PRELIMINARY OVERALL
AREA DEVELOPMENT PLAN
SOUTHSIDE I. S. D.
LOOP 1604 FACILITIES

Re: Southside ISD Loop 1604 Facilities

POADP # 610

P.O.A.D.P. REVIEW

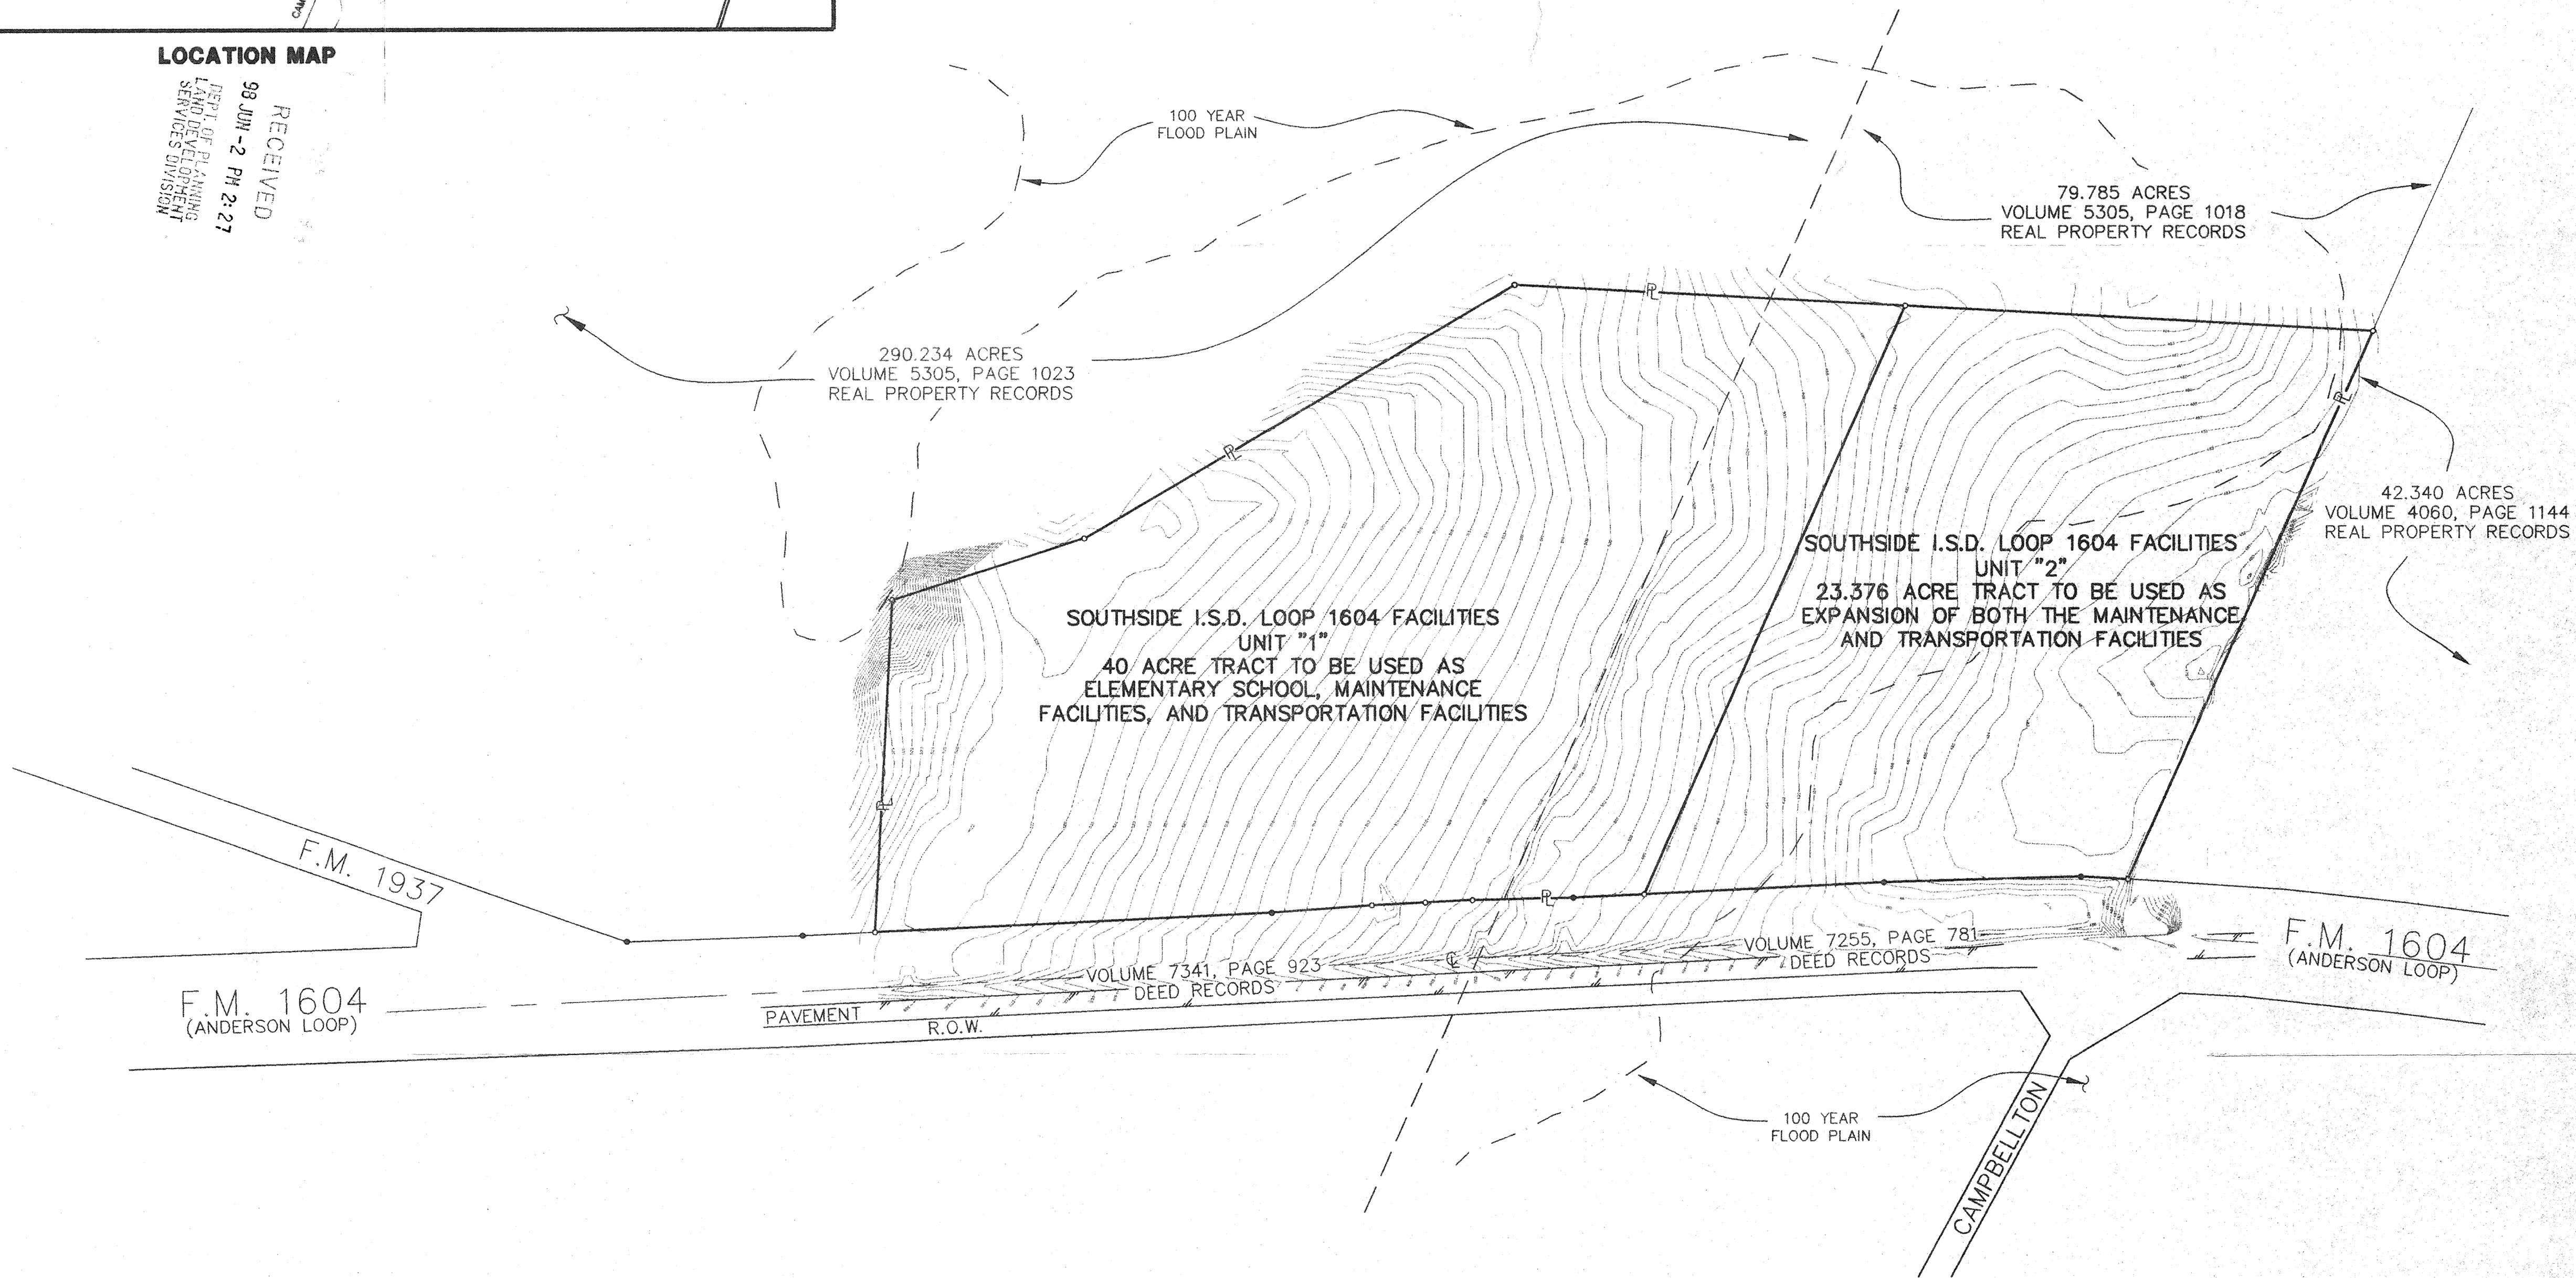
- Based on the topography, a Flood Plain Study and drainage review will probably be required during the platting process.
- Access and R.O.W. issues along State facilities will need to be resolved with the Texas Department of Transportation (TXDOT). For information about these requirements you can contact TXDOT at 615-5814.
- This development will need to comply with tree preservation ordinance #85262. For information about these requirements you can contact Building Inspections at 207-7102.
- It will be expected that you will plat all of the property depicted in your POADP, to include: floodpains, drainage areas and open space.
- I would encourage you to work closely with the school district, so that they can plan accordingly.
